Outbound Maneuvers without South Capitol Street Oval

Outbound Maneuvers with South Capitol Street Oval

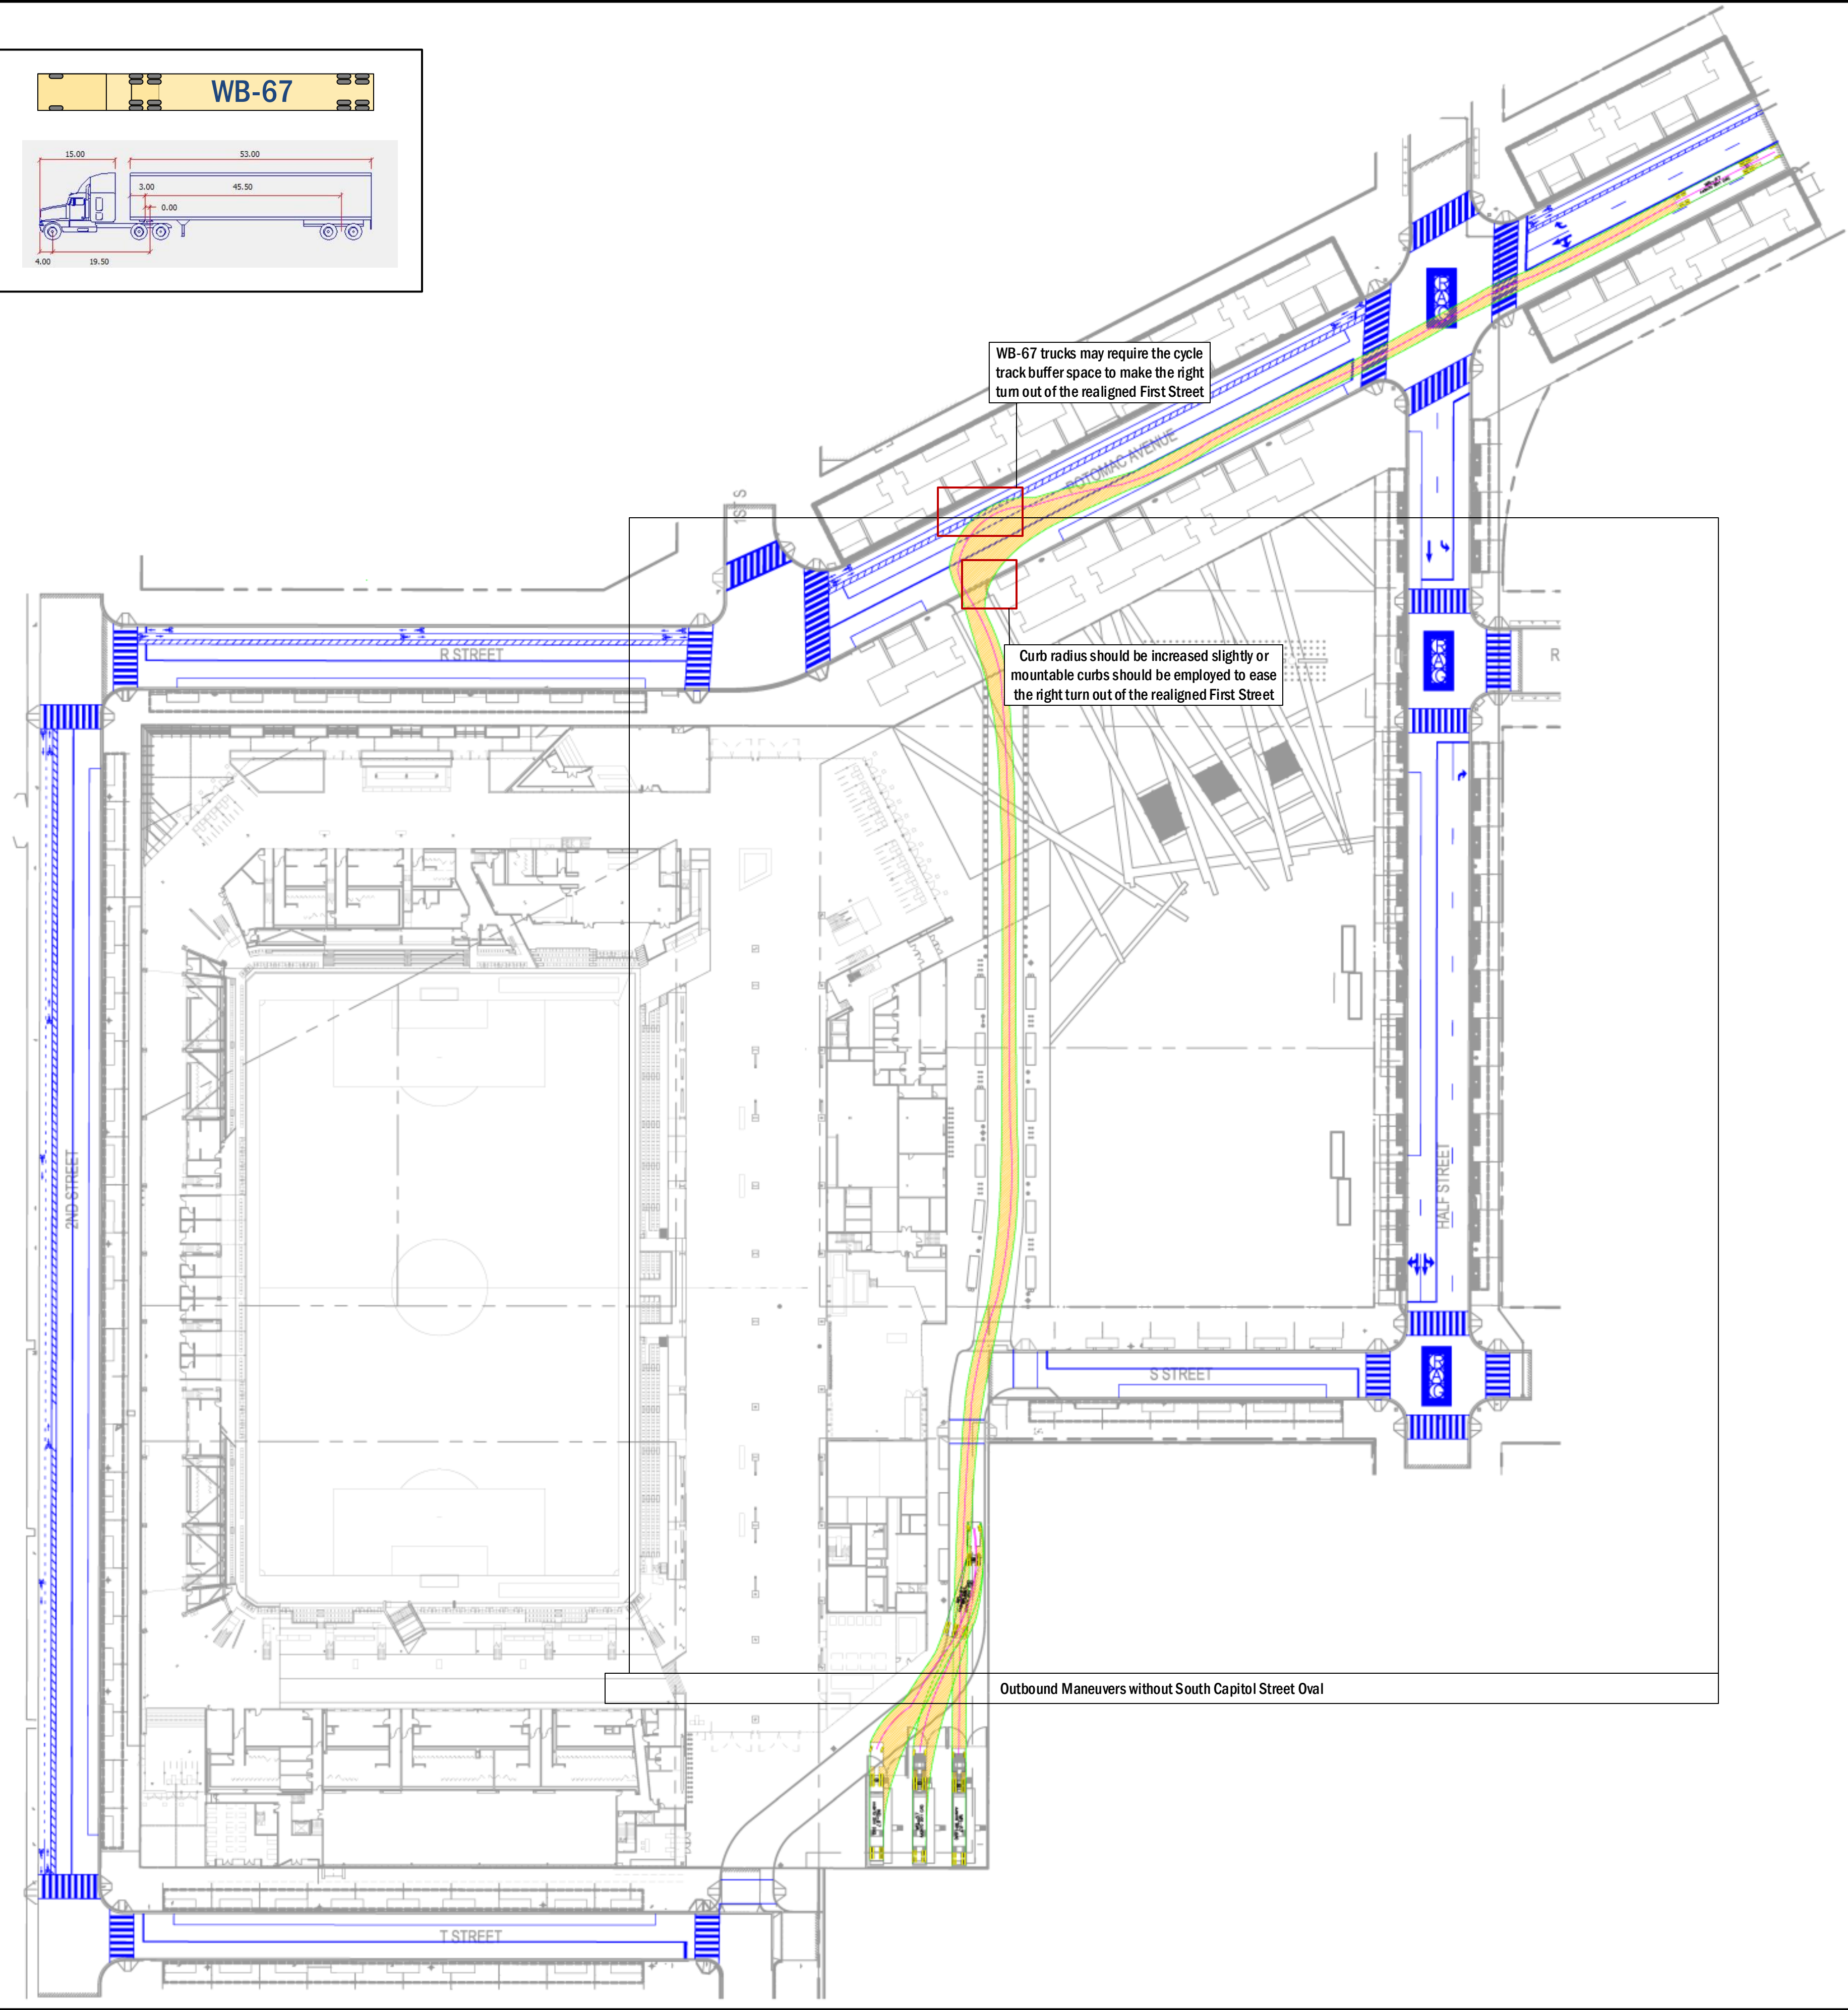
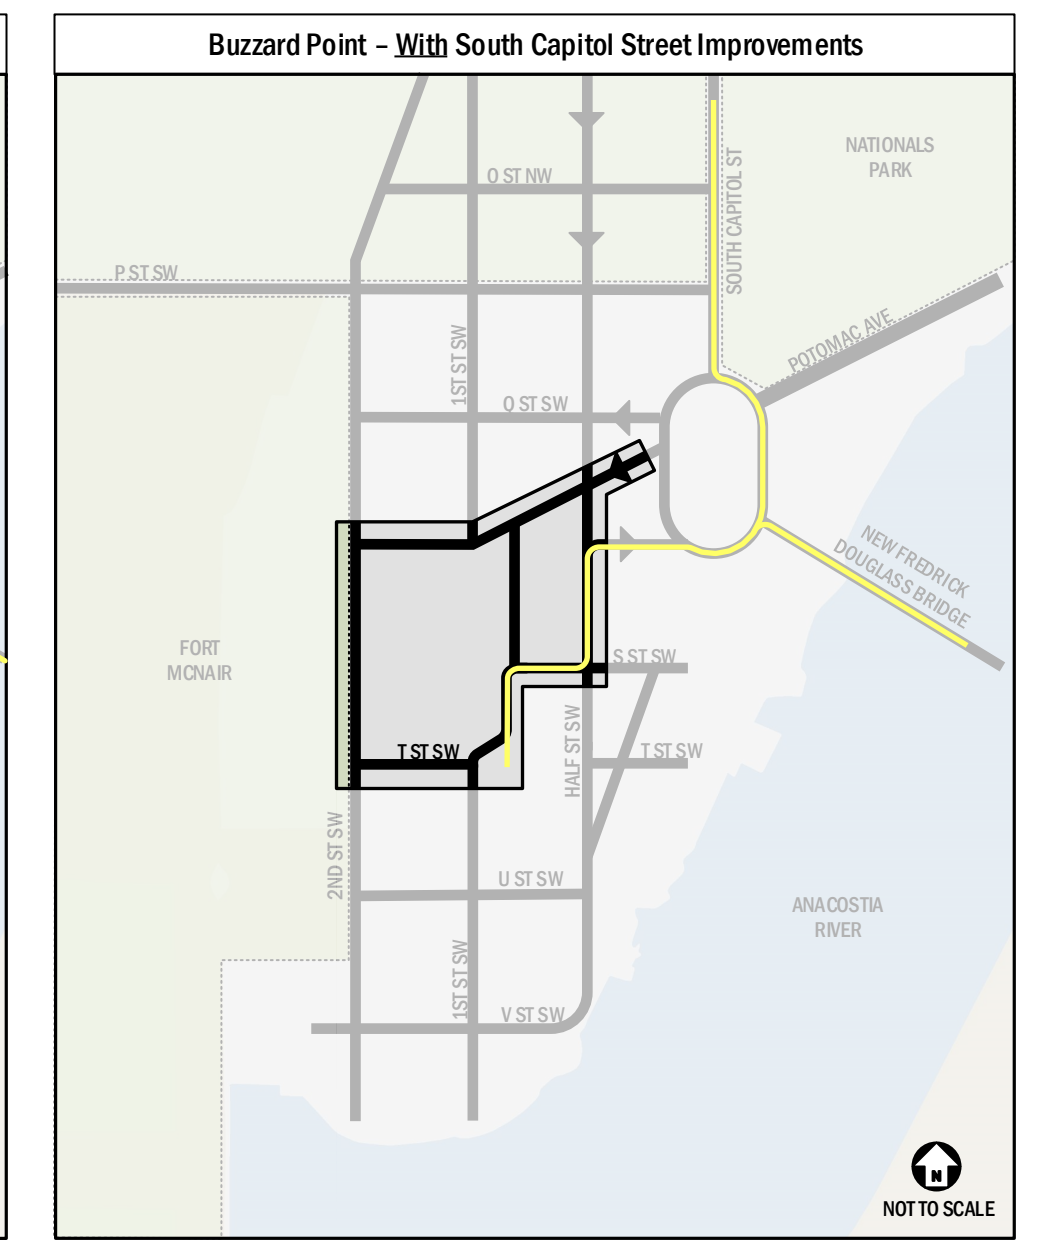
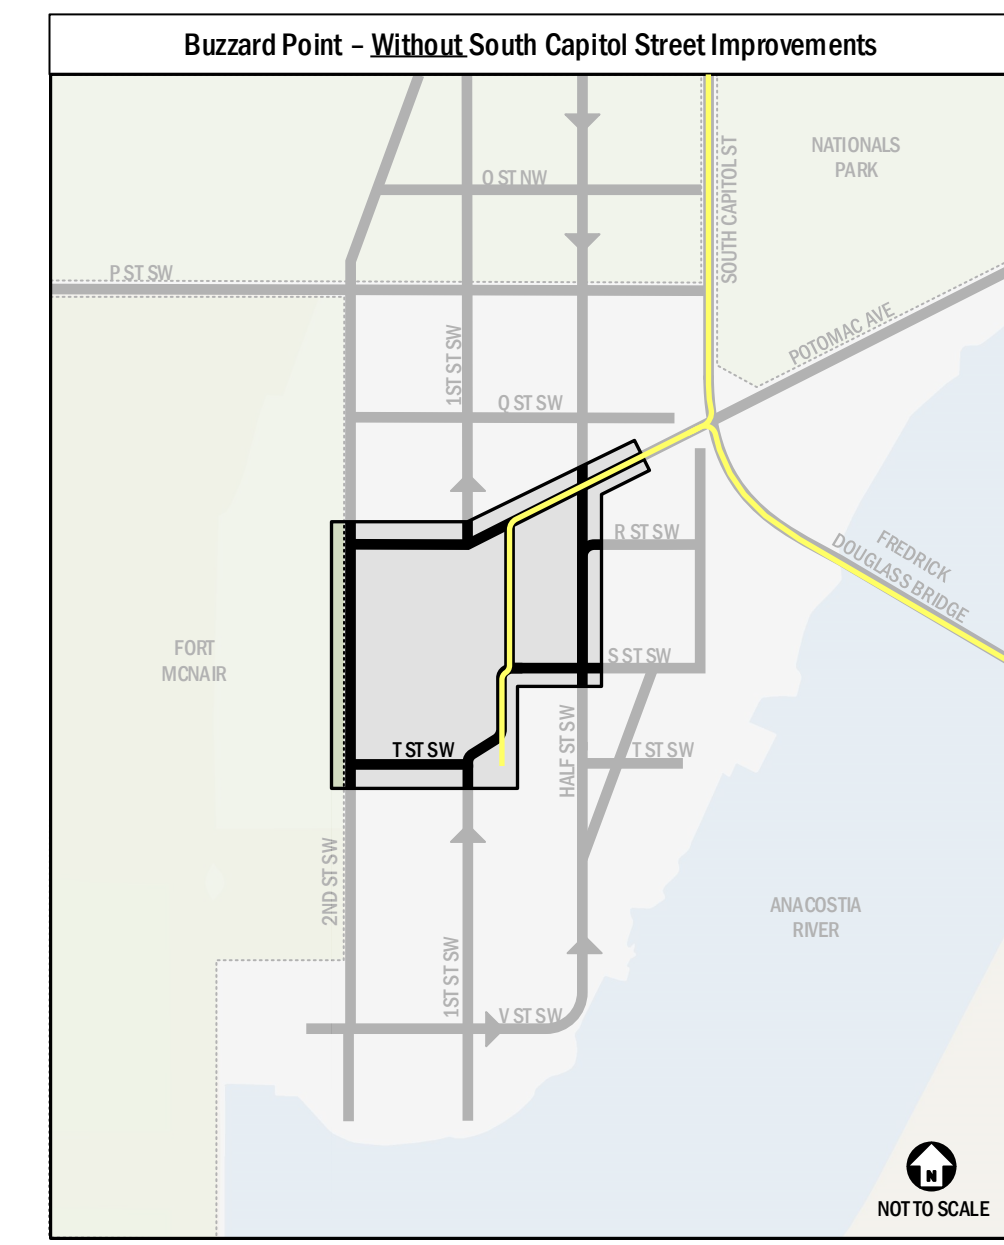
Mountable curbs or increased curb radii should be employed to ease the right turn onto S Street. This right turn will be necessary when the South Capitol Street Oval is constructed and Potomac Avenue between Half Street and South Capitol Street becomes one-way westbound.
